Reply to Reviewers' Comments on Manuscript HESS-2020-87

We thank the Editor, Associate Editor and the anonymous reviewers for their thoughtful and insightful review comments. The manuscript has been substantially revised, and an item-by-item response to the review comments is provided below.

Figure C.1. Maps of six parameter sensitivity indices for groundwater contribution to stream flow (Q_G) predictions.

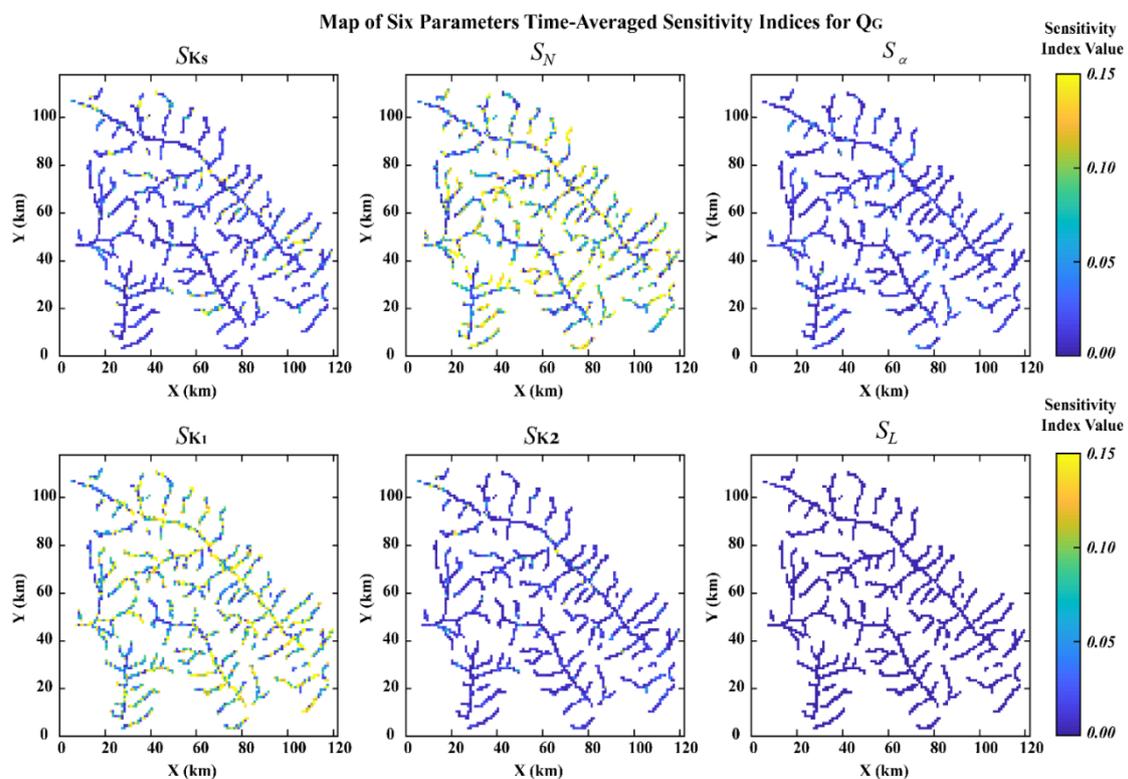
Line 346: It is good to investigate the contribution of groundwater system to stream-flow, and this research find that the thickness of an aquifer will greatly influence the water redistribution process in the aquifer. However, I want to see the influences of aquifers' thicknesses on streamflow in more detail, such as, the unconfined aquifer and the confined aquifer, It is expected that the unconfined aquifer has more influence on streamflow, because it has stronger interaction with surface flow.

We thank the reviewer for the suggestion. And we think the comparison for the importance of unconfined and confined aquifers is indeed worth to investigate. However, limited by the scope of this study, we compared the hydraulic conductivity of the unconfined aquifer with that of the confined aquifer, rather than the thicknesses of aquifers. We think this also explains to a certain extent which aquifer has a greater influence on Q_G . In this regard, we have added Appendix C and Fig. (C.1) to display the results. The results confirmed that the unconfined aquifer has more influence on streamflow.

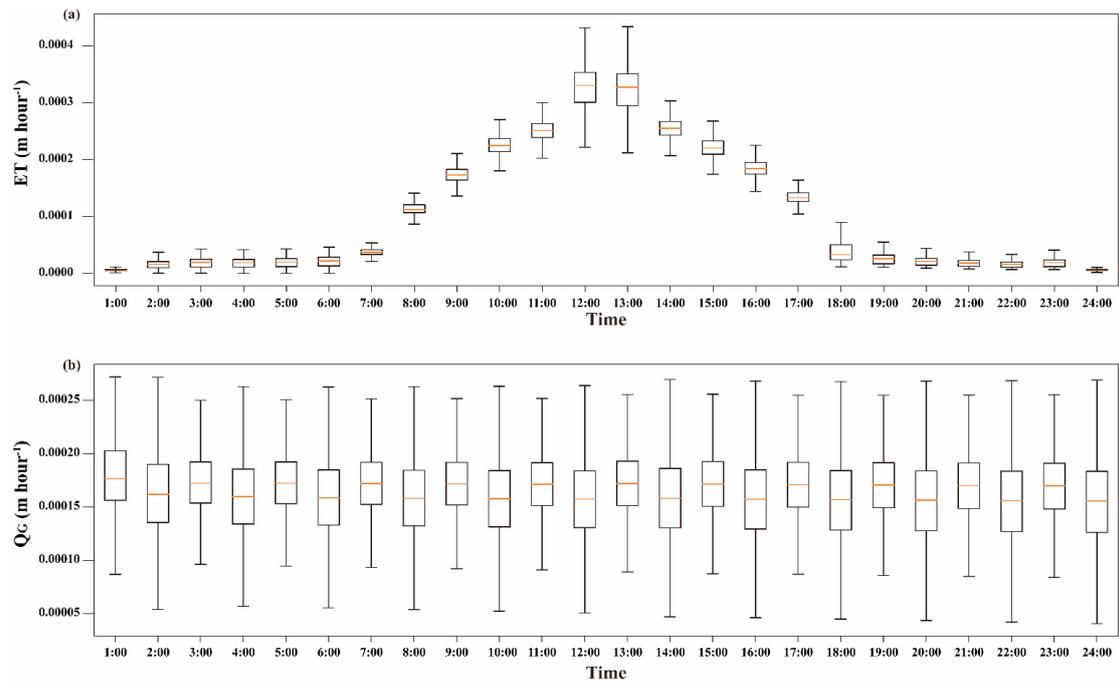
Figure 4 is a big mess. A cleaner representation such as a boxplot is required.

We have replaced this figure to exhibit the great uncertainty of the model simulation results.

Figure 2

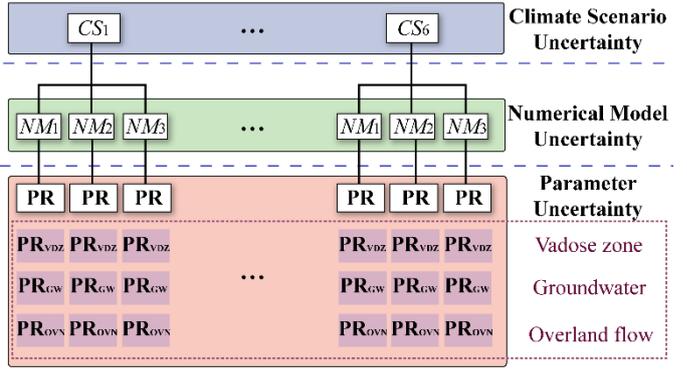
The words in Figure 2 are hard to read.

We have updated this figure using a higher resolution and a larger font.

Figure 7

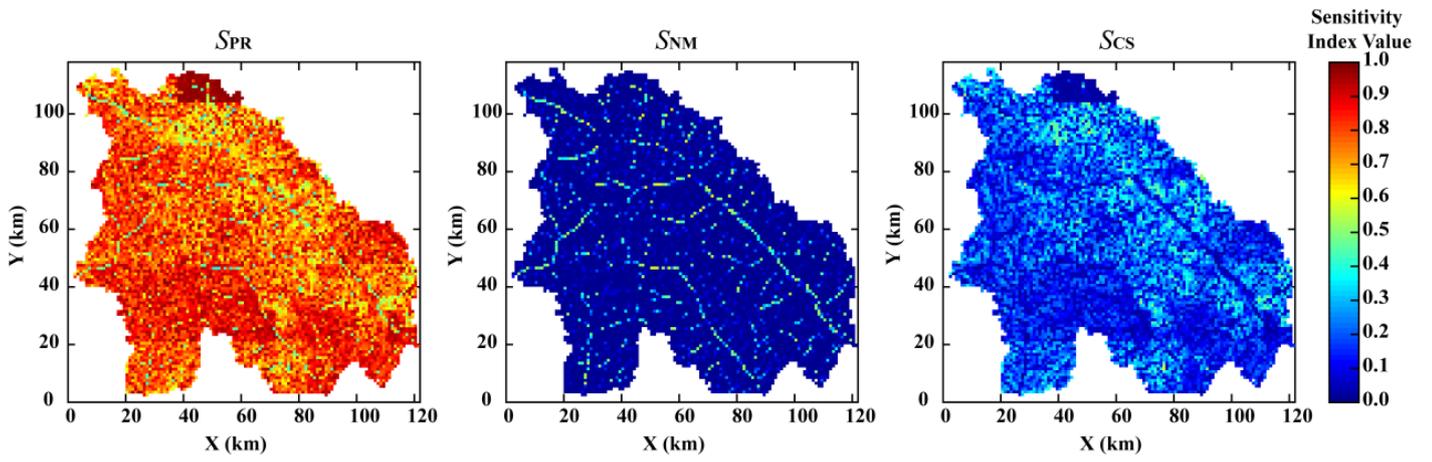
Conversely, some figures deserve more discussion, e.g., Figure 7 – I do not think it is the thickness right under the river cells, it's about overall thickness and how much water

We agree with the reviewer that in Figure 7, the sensitivity index for aquifer thickness is about the average aquifer thickness for the whole watershed, rather than the thickness ‘right’ under the river cells. This is because the volume of groundwater to the river considers the contribution of overall watershed grids. We have replaced the relevant expressions in the manuscript.

905 Figure 9

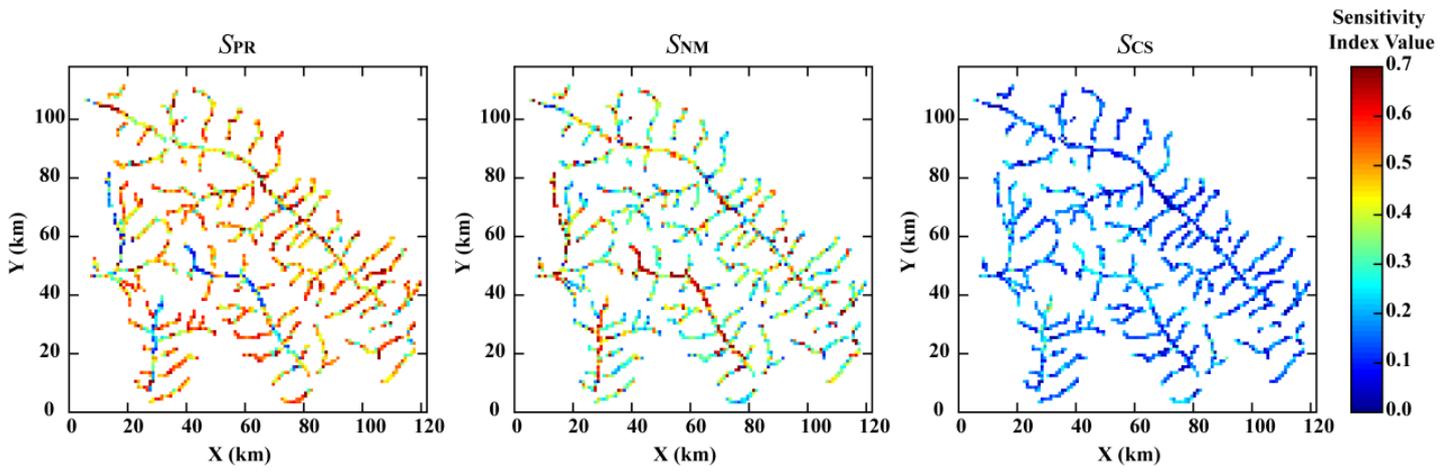
from the watershed concentrates to the channels. This hypothesis can be tested; Figure 9 – headwater vs stem river cells. Figure 11 – not really discussed much.

As for the Figure 9, we have added more discussions about the difference between groundwater and stem river cells as follows:
